**Final Initial Study/Mitigated Negative Declaration**  
**for the**  
**CARMEL RIVER FLOODPLAIN RESTORATION**  
**AND**  
**ENVIRONMENTAL ENHANCEMENT PROJECT**  
**SCH#2011021038**

**April 15, 2010**

## 2.0 RESPONSE TO COMMENT

Figure  
**1.8**

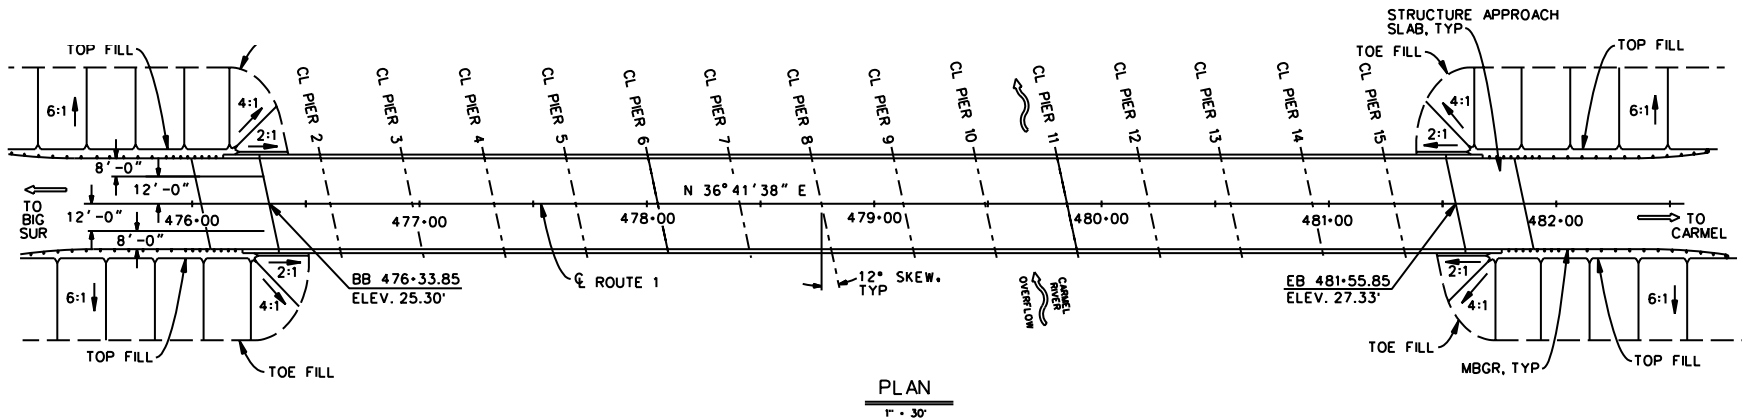
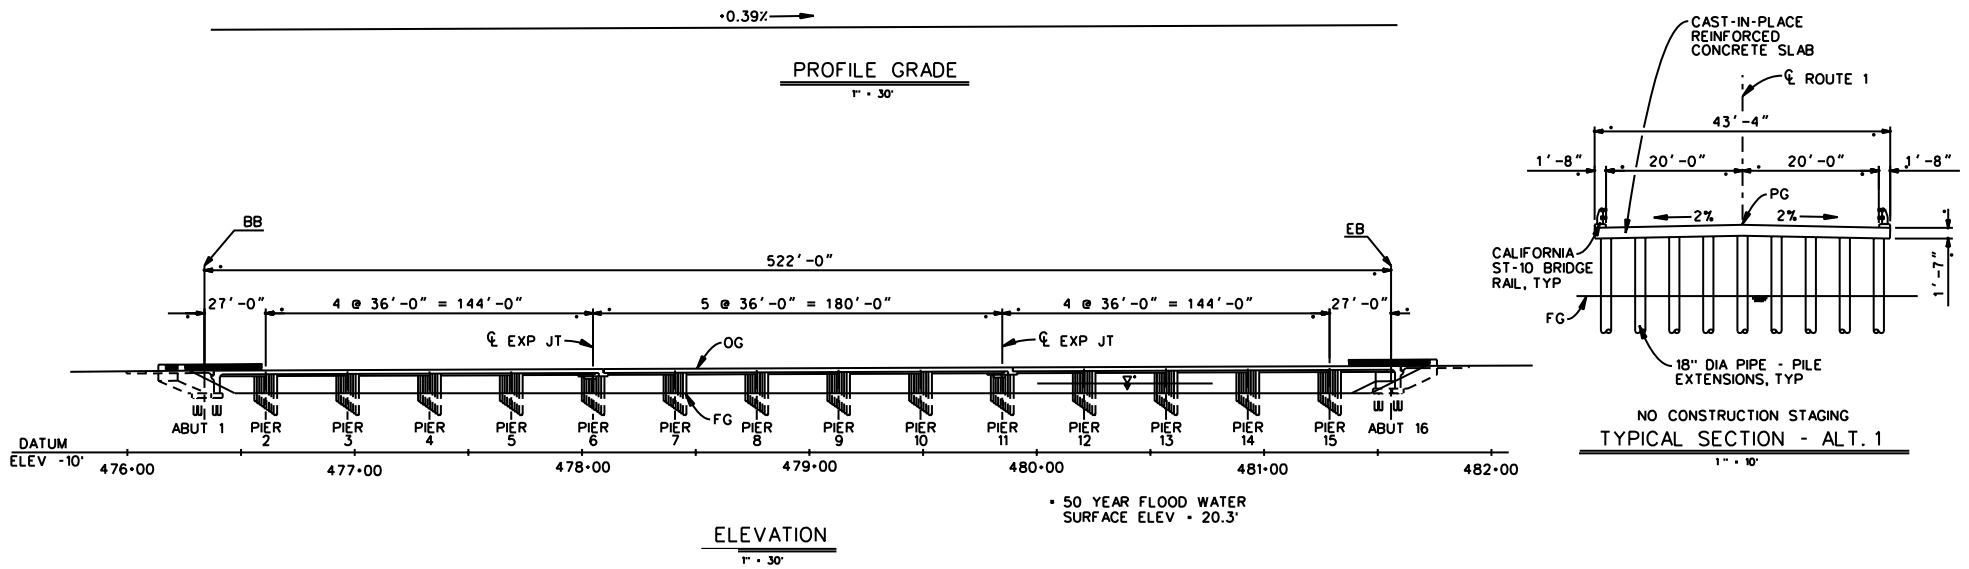
Vertical Datum – elevations given in the draft document and in reports and drawings contained in the Appendices are not consistently referenced to a generally accepted datum. For example, Section 1.2.1 “Odello East Component” describes the site as being “...approximately 18 to 55 feet above mean sea level.” The U.S. Geological Survey and the Federal Emergency Management Agency phased out references to elevation above sea level (i.e., the mean Sea Level Datum of 1929) beginning in the 1970s and instead, the National Geodetic Vertical Datum (NGVD) of 1929 was widely adopted. Recently, NGVD 1929 has been replaced by the more accurate North American Vertical Datum of 1988 (NAVD 88).

Correctly identifying which datum is being used has important consequences in understanding how this project may affect flood elevations. For example, Figure 1.8 shows that the 50-year flood water surface elevation at Highway 1 is equal to 20.3 feet. No datum is specified and presumably the elevation shown is post-project. The Flood Insurance Study (FIS), Monterey County, Plate 19P, Volume 2 of 3 April 2, 2009 shows that the 50-year water surface profile immediately upstream of Highway 1 is at an elevation of almost 26 feet (NAVD 88). It appears that most of the hydraulic analysis presented in the Appendices and report is tied to NGVD 1929, whereas the FIS is tied to NAVD 88. We recommend clearly identifying which datum is being used on all drawings and references to elevations for this project.

- D-4:** This comment suggests that additional information be provided regarding the vertical datum used in the Draft IS/MND. The commenter notes that both the U.S. Geological Survey and the Federal Emergency Management Agency (FEMA) phased out references to elevation above sea level in the 1970s and have instead relied on the National Geodetic Vertical Datum (NGVD) 1929 until recently. Recently, the NGVD 1929 was replaced with the North American Vertical Datum of 1988 (NAVD 88). This comment further suggest that the text of the Draft IS/MND be revised to clarify which datum was used. At the time that the supporting technical reports were prepared by Balance Hydrologics, Inc. and Avila and Associates, the NGVD29 datum was the datum used on the FEMA mapping. These reports were prepared using the NGVD29 datum. According to FEMA, the appropriate conversion from NGVD29 to NAVD88 for the Carmel River is the NGVD29 elevation plus 2.82 feet. In response to this comment, the Draft IS/MND has been revised to clearly state the vertical datum and incorporate MPWMD's suggested revisions. Please refer to **Section 3.0 Revisions to the Draft IS/MND** for more information.

**Figure 1.8, Preliminary Causeway Design, Page 18, is revised as shown on the following page.**
